**Agenda**  
**Hailey Planning and Zoning Commission**  
**Monday, April 21, 2025**  
**5:30 p.m.**

- [PH 1](#) Consideration of a Design Review Pre-Application by Dale and Lia Johnson, represented by Chrysalis Architecture and Planning, for the construction of three (3) new mixed-use buildings, each building approximately 9,532 square feet in size. Each building is proposed to comprise of four (4) mixed-use units, each unit containing 900 square feet of residential area and 1,393 square feet of commercial area. Twelve (12) mixed-use units are proposed overall for the site. This project is proposed to be located at 1611 Aviation Drive (Lot 3B, Blocks 4, Airport West Subdivision) within the SCI-Industrial (SCI-I) Zoning District.

**Hearing:** April 21, 2025

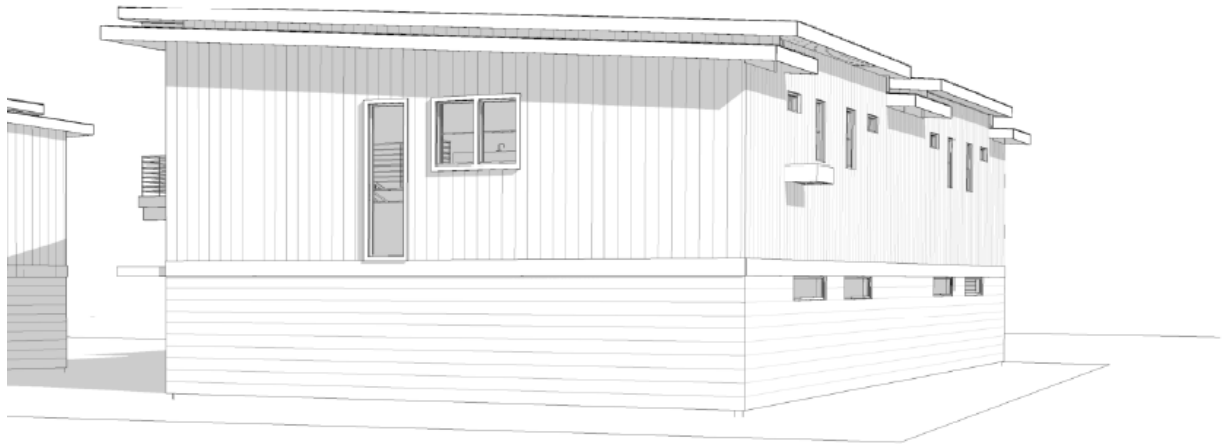
- 2. Building Design, Materials, and Colors:** The Applicant is proposing each of the three (3) building heights at thirty-three (33) feet. The proposed building design includes slate gray, vertical lap siding; natural finish, wood lap siding highlighting the buildings' first floors and second-floor outdoor patio areas; white window trims; black metal fascia and roofing material; and light gray garage doors and belly bands. Shed rooflines are proposed for each building, with variety in pitch orientation shared across each structure. Window shapes vary

from large, vertical windows with clerestory features, to smaller horizontal privacy windows in living areas/bedrooms.

As illustrated in the Google Earth photos below, the use of natural materials and earth tone color palettes is somewhat common in this extent of Aviation Drive. The proposed building design complements this existing pattern. However, proposed building site is currently being used for surface storage of a variety of industrial and commercial materials (bottom photo), and is somewhat lacking in character/organization. The proposed mixed-use building design will provide a balance of both commercial and pedestrian/residential presence to the area, anchoring the corner property and surrounding portion of the Airport West Subdivision.

However, the east-facing façade of Building 1, directly adjacent to Aviation Drive, is significantly lacking in architectural detailing, variety in materials and colors, and pedestrian

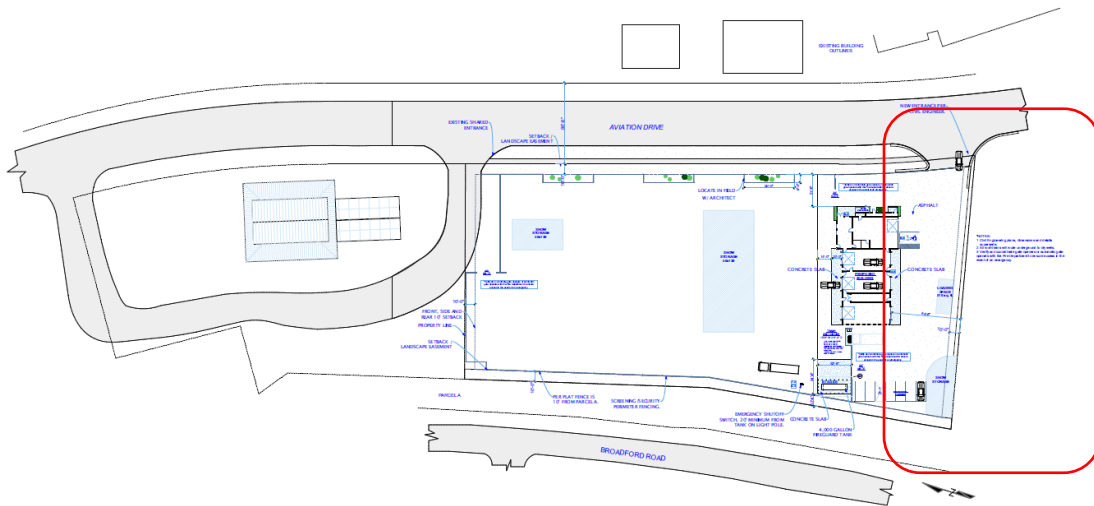
The modifications listed below are minor in the overall scope. The proposed modifications consist of:  
Amended Site Plan:

- The fuel tank has been moved South and placed on a larger integrated support and access pad. The light, signs and bollards have been adjusted accordingly.

- The asphalt surrounding the building aligns with the edge of the tank pad and is slightly further from the Western property line.
- Added concrete aprons on either side of the building for durability.
- The building moved 5' to the West to provide more room on the Eastern side to approach the exit/entrance.
- Moving the building also necessitated slight adjustments to the gates.
